Author's reply to Comment on [essd-2022-466](#) by Dr. Paola Picco

Author's reply to Comment on [essd-2022-466](#) by Anonymous Referee #2

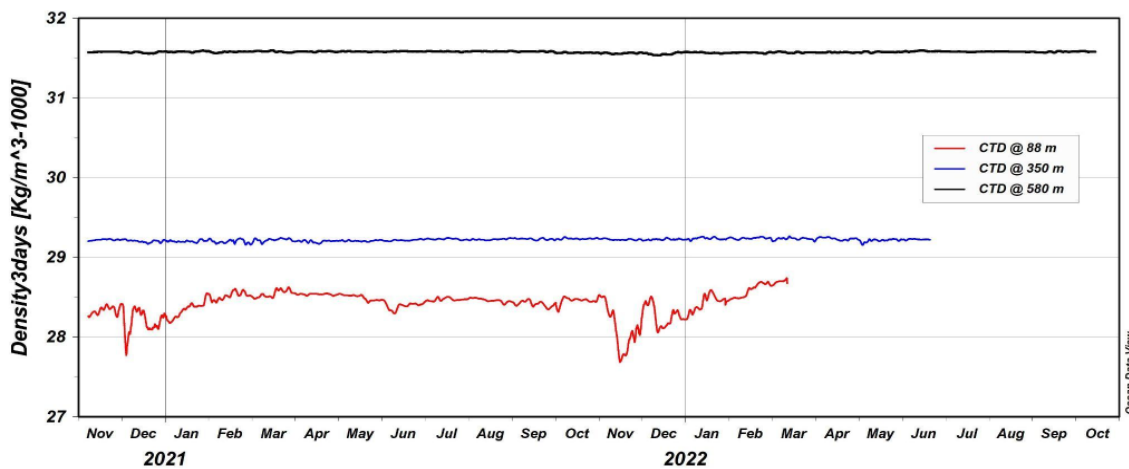
d) Salinity data at 350 m depth seem unreasonable for the investigated area and not consistent with the values at the other depths. To this end, I suggest to plot computed density in order to check for the stability of water column or to go back to fig.5 which indicates the LIW denser than waters at higher depths, which is not possible. Even this problem is addressed at the end of ch.4, it still requires a deeper discussion. As these data were not checked against laboratory salinometer analysis of in situ samples nor compared with CTD profiles and do not seem to satisfy vertical stability, it should be better not to make them available to the scientific community.

AR: In Figure 5 there was an error related to reported density values for all the three water levels. The following Figure, showing density time-series for the three levels, shows that the vertical stability of the water column is indeed satisfied.

Nevertheless, as density and salinity values recorded by the CTD at 350 m depth are high for the investigated area we decide to flag them as potentially correctable bad data in the re-submitted data set (<https://doi.org/10.17882/92236>). In order to fix this, future measurements were already planned to be checked against a laboratory salinometer and compared with concomitant CTD profiles.
